**BIT AND SPUR WOODS SUBDIVISION,**  
**RESUBDIVISION OF LOT 3**

APPLICATION NUMBER 12 DATE January 7, 2010

REQUEST Subdivision

## DETAIL SITE PLAN

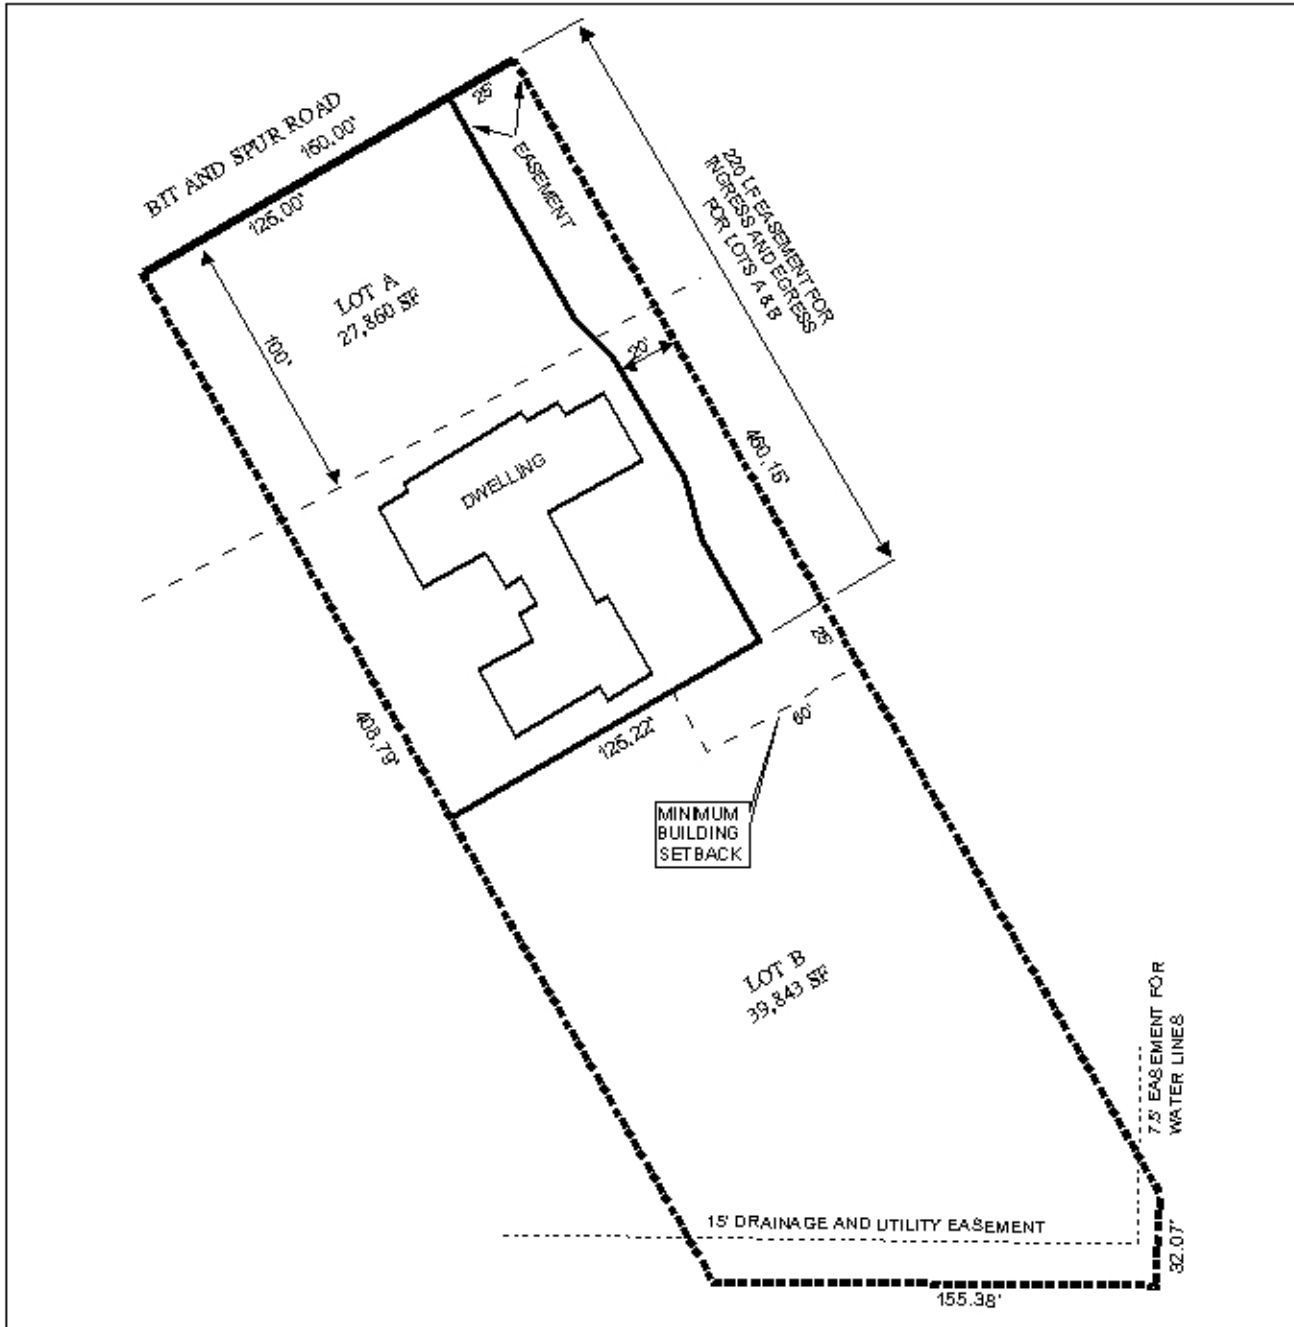
The plat illustrates the current 100' minimum building setback line along Bit and Spur Road for proposed Lot A, and this should also be shown on the final plat. For proposed Lot B, the 25' minimum building setback line should be revised to be measured from all parts of the proposed new East-West interior lot line. Each lot is labeled with its size in square feet and this should also be done on the final plat, or a table should be furnished on the final plat providing the same information. The lot size labeling should reflect any changes due to any required reconfiguration of the lot shapes.

As this is a flag lot subdivision, such are generally prohibited by the 2008 revision of Section V.D.1. of the Subdivision Regulations. However, an allowance is provided in locations where varied or irregularly-shaped lot designs are common and the informality of design is consistent with other lots in the vicinity. In this instance, the adjacent property on the West side was approved in 1997 as a two-lot subdivision containing a similar flag lot. Therefore, justification for this subdivision would exist. But unlike the adjacent flag lot which has a “pole” access 25’ in width its entire length, the proposed flag lot constricts from 25’ to 20’ to allow a 9’ setback off the East side of the existing dwelling on proposed Lot A. Section V.D.1. of the Subdivision Regulations specifically states that where panhandle or flag lots are permitted, the “pole”, “handle” or “stem” shall be a minimum of 25’ in width for its entirety. Therefore, the plat should be revised to indicate the “pole” to be 25’ in width its entire length. Since this would reduce the setback off the East end of the existing dwelling to 4’, the applicant should seek and be granted a Side Yard Setback Variance from the Board of Zoning Adjustment prior to the signing of the final plat. The current side yard setback on the opposite side of the dwelling is indicated to be approximately 30’ which would be sufficient to meet the combined side yard total requirement of 20’.

- 2) illustration of the current 100’ minimum building setback line along Bit and Spur Road for Lot A;
- 3) revision of the plat to illustrate the 25’ minimum building setback line for Lot B as measured along the entire length of the new East-West interior lot line;

- 5) revision of the “pole” for Lot B to 25’ in width for its entire length;
- 6) approval of a Side Yard Setback Variance by the Board of Zoning Adjustment for the reduced setback off the East end of the existing dwelling prior to signing the Final Plat;
